EPA Tier 1 Comments - Draft EW Subsurface Sediment QAPP

EPA Comments – East Waterway Subsurface Sediment QAPP (04/17/2009 Draft)

Draft Subsurface Sediment Sampling for Chemical Analyses in the East Waterway (April 17, 2009)

Subsurface sediment sampling locations for the SRI with historical exceedances of SMS criteria and DMMP guidelines for surface and subsurface sediment - North East Waterway Study Area

Rationale for revisions to subsurface sediment core locations (Maps 2-2a and 2-2b)

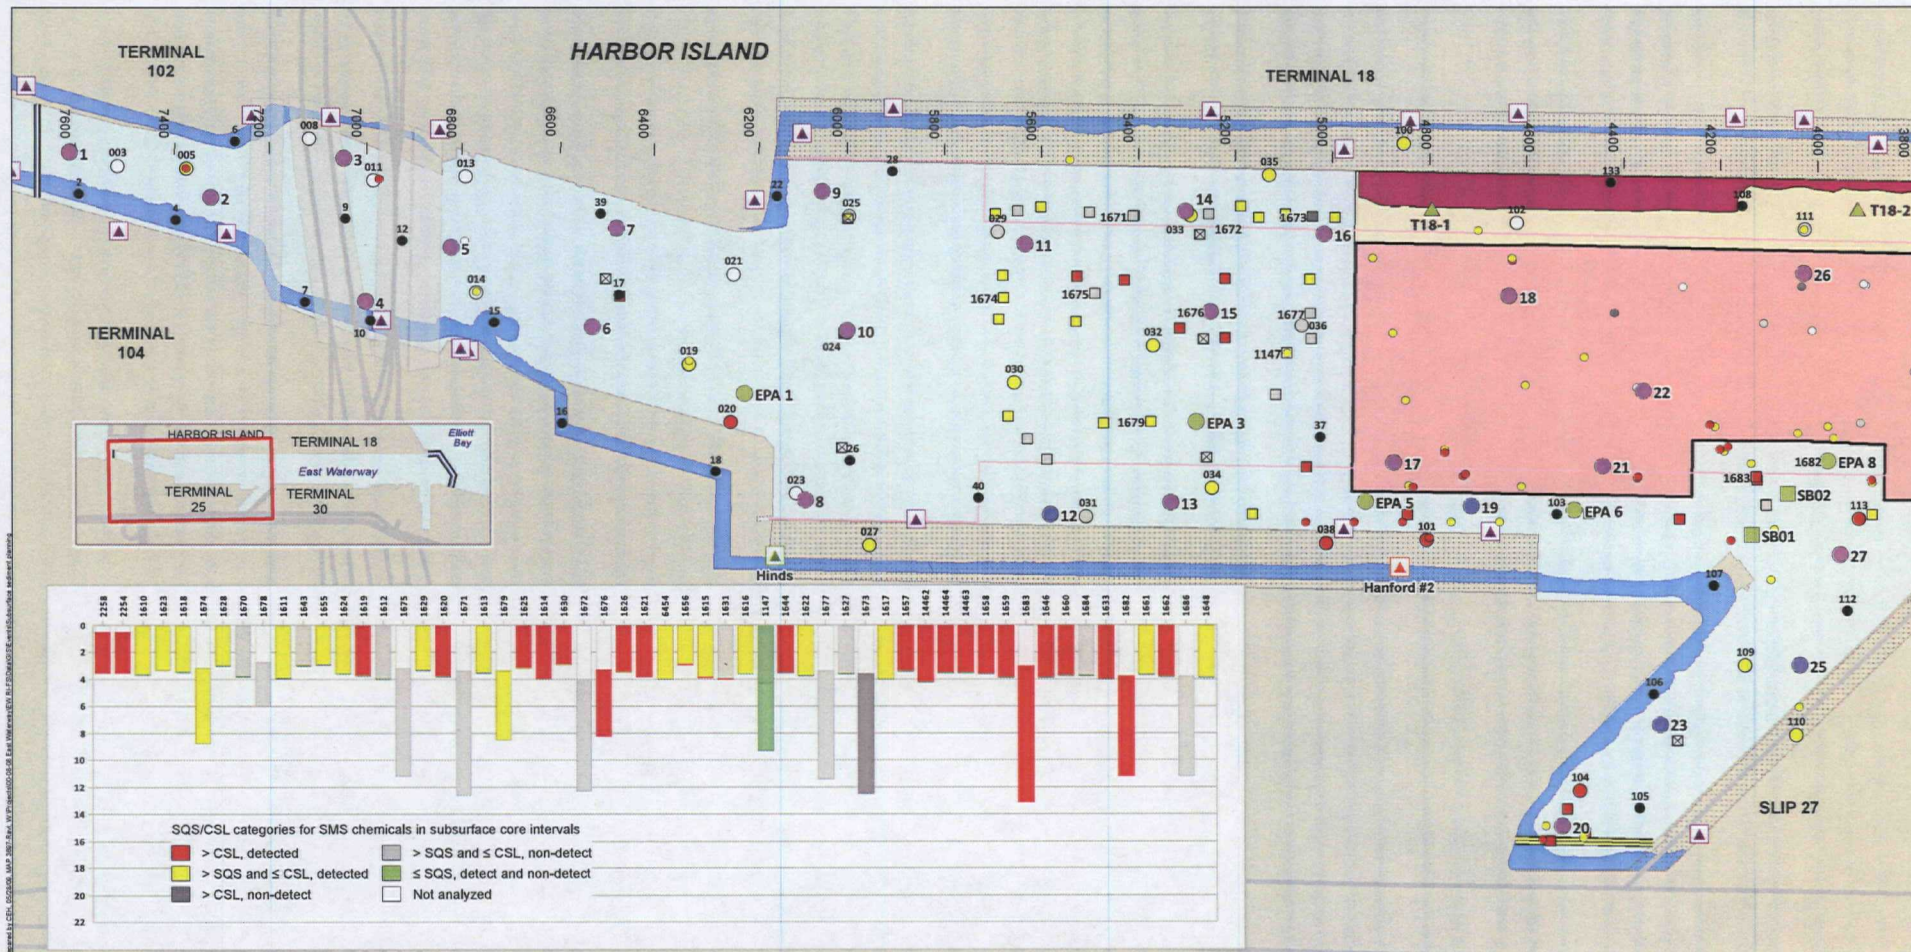
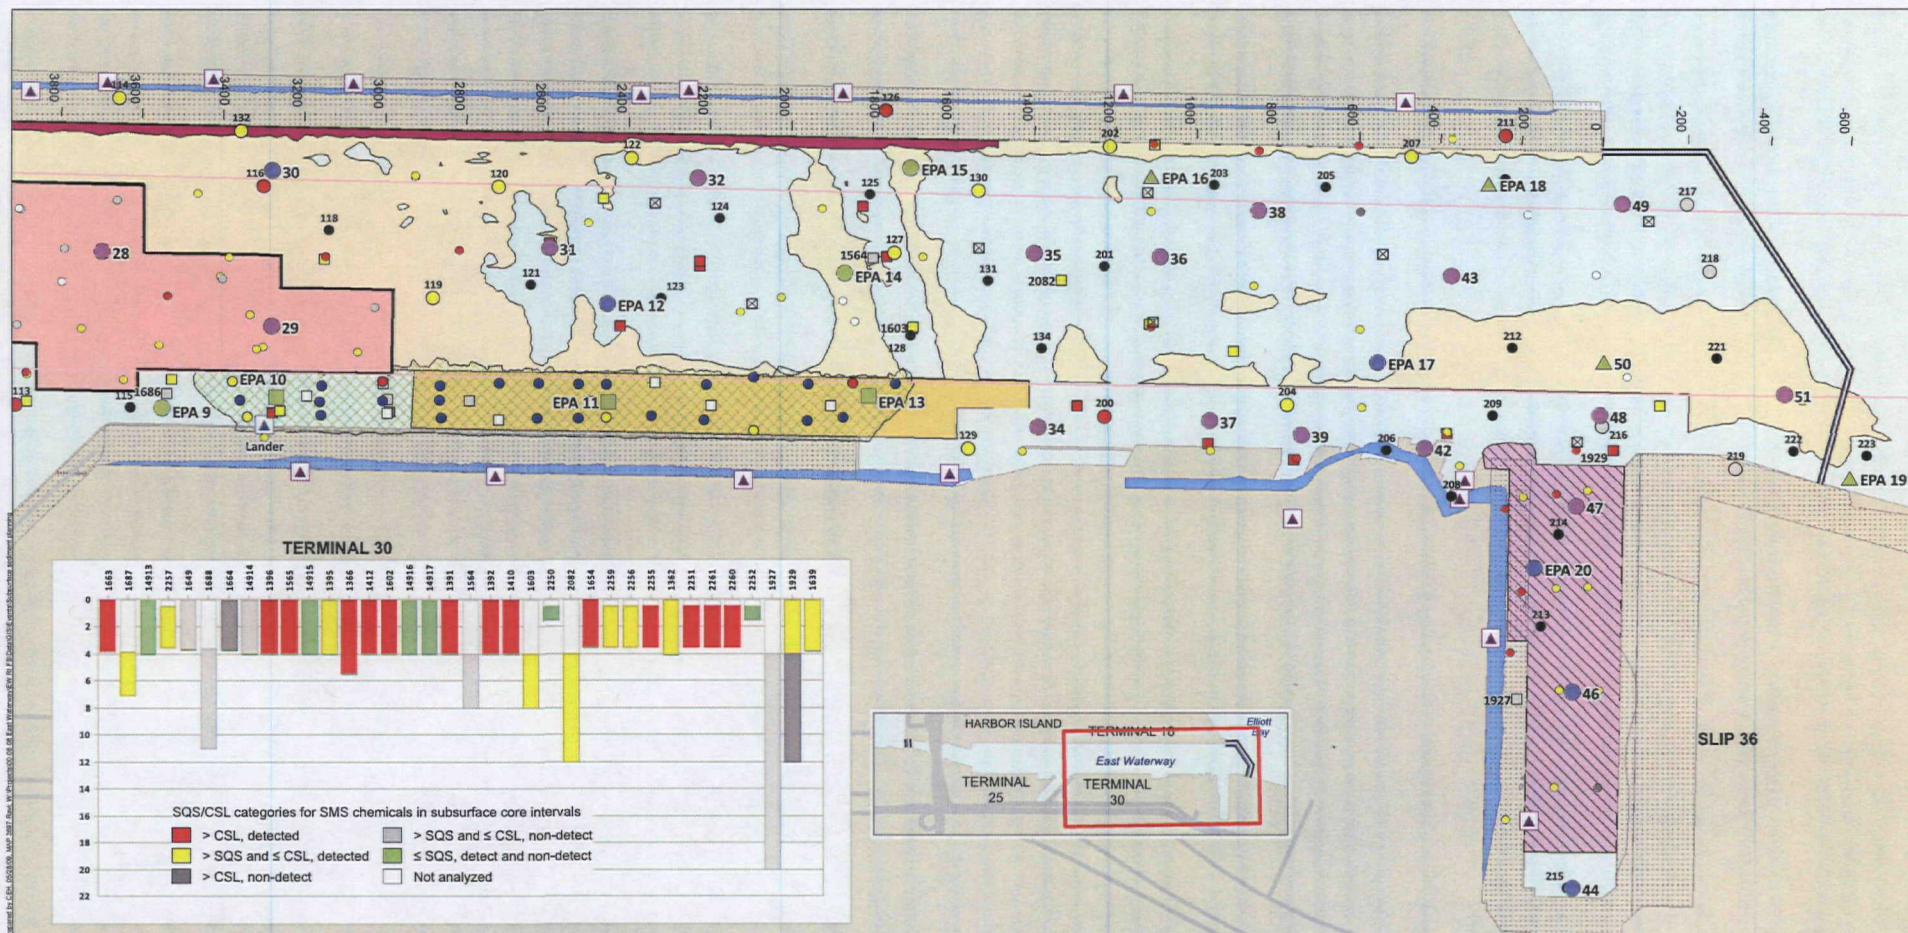
55	Map 2-2	Map 2-2	Please revise Maps 2-2 a and b so that they are presented at the same scale.
56	Map 2-2	Map 2-2 (a&b)	Please revise the Maps to include all EPA additional cores as depicted on the attached figures and table.
57	Maps	Maps	Please include a map of current bathymetry at the same scale as Maps 2-2a and b.
58	Maps	Maps	Please add the geotech locations to the subsurface sediment sampling location maps.

Sample	Rationale
EPA 1	Investigate potential vertical extent of contamination outside of surface sediment CSL exceedance (020). Inform on conditions at T25. Location could be modified based on results from Round 2 surface locations 16 and 18
1674	No new core required to investigate depth of SQS exceedance below previous 8 foot core (1674). EPA will assume contamination extends to deepest historical depth.
12	Proposed EWG location was moved closer to pier face to investigate depth of contamination near previous SQS exceedances.
EPA 3	Investigate depth of contamination below previous CSL exceedance.
EPA 5	New core to delineate extent of Hanford footprint.
19	Original EWG location moved south to delineate extent of Hanford footprint.
EPA 6	New core to delineate extent of Hanford footprint.
24	Not needed because chemistry will be collected with geotech core SB02.
EPA 8	Investigate depth of contamination below previous CSL exceedance. This area is closer to the Phase 1 removal area than proposed geotech core SB02 (and former EWG proposed subsurface location 24), and the vertical profile may be different. Locate near former sampling locations 1633 and 1682.

23	Original EWG Location was moved south.
25	Original EWG Location was moved north.
T18-1	Pending Round 2 surface sediment results, additional core may be needed near the pier face of T-18 between roughly 3800 and 4800.
T18-2	Pending Round 2 surface sediment results, additional core may be needed near the pier face of T-18 between roughly 3800 and 4800.
EPA 9	Investigate depth of contamination below previous CSL exceedance. Area not previously dredged.
EPA 10	New core to characterize T-30 area and delineate extent of Lander footprint. Shorter core may be collected, but EPA requires full delineation of depth of contamination. EPA does not assume that native material is clean.
30	Original EWG Location was moved closer to previous CSL exceedance (116) to investigate depth of contamination.
EPA 11	New core to characterize T-30 area and investigate depth of contamination near previous SQS exceedance. Shorter core may be collected, but EPA requires full delineation of depth of contamination. EPA does not assume that native material is clean.

EPA 12	Original EWG location 33 moved to EPA 12 to investigate depth of contamination below previous CSL exceedance.
33	Original EWG Core replaced with EPA 12.
EPA 13	New core to characterize T-30 area and investigate depth of contamination near previous CSL and SQS exceedances. Shorter core may be collected, but EPA requires full delineation of depth of contamination. EPA does not assume native material is clean.
EPA 14	Investigate depth of contamination near previous SQS (127) and CSL exceedances near utility corridor.
EPA 15	New core near T-18 pier face to investigate extent of contamination near previous CSL exceedances (126 under pier and un-labeled core outside pier).
EPA 16	Pending Round 2 surface sediment results, new core to investigate contaminant concentration depth.
EPA 17	New core offshore of GATX. Could replace proposed EWG location 40

Sample	Rationale
40	Original EWG Core replaced with EPA 17.
EPA 18	Pending Round 2 surface sediment results, new core (relocated location 41) near pier face to investigate extent of contamination near previous CSL exceedance (211) (Kinder Morgan site).
50	Pending Round 2 surface sediment results, original EWG location moved into dredged area.
EPA 19	Pending Round 2 surface sediment results, contingent locations for new core.
EPA 20	Original EWG location 45 moved to investigate depth of contamination near previous creosote pier to evaluate variation in depth of contamination as move from offshore of likely source area.
44	Original EWG location moved east out of dredged area.
